**NFPA Correlating Committee on National Electrical Code® (NEC AAC)  
NFPA 70® Second Draft Meeting (Annual 2025)  
NFPA 73 Second Draft Meeting (Annual 2025)  
NFPA 70E® First Draft Meeting (Annual 2026)**

January 14 - 17, 2025  
8:00 a.m. – 5:00 p.m. (ET)

5. **Previous meeting minutes.** August 28, 2024, Remote meeting via Microsoft Teams. See attached.
6. **NFPA 70® Second Draft.**
  - a. **Second Revisions/Public Comments.** See attached.

**Figure 90.4 Standard Arrangement.**

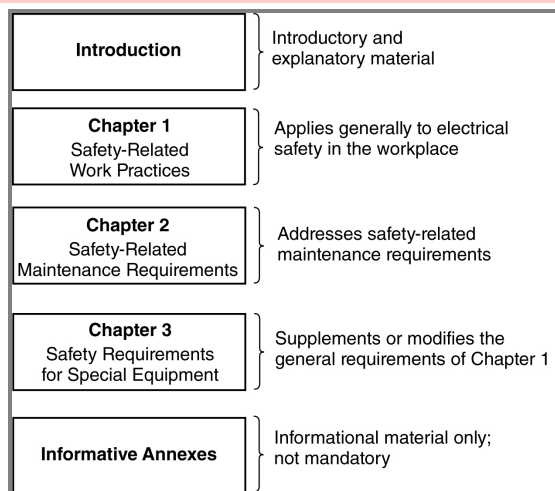
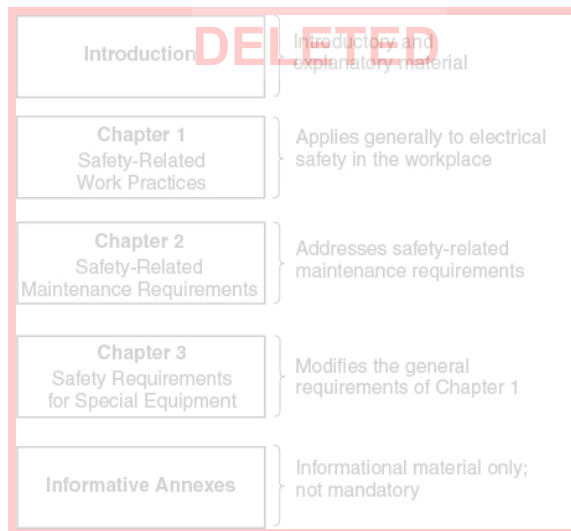
**Committee Statement:** The text in the Chapter 3 row of Figure 90.4 is modified to align with the provisions in Section 90.4 for correlation and clarity.
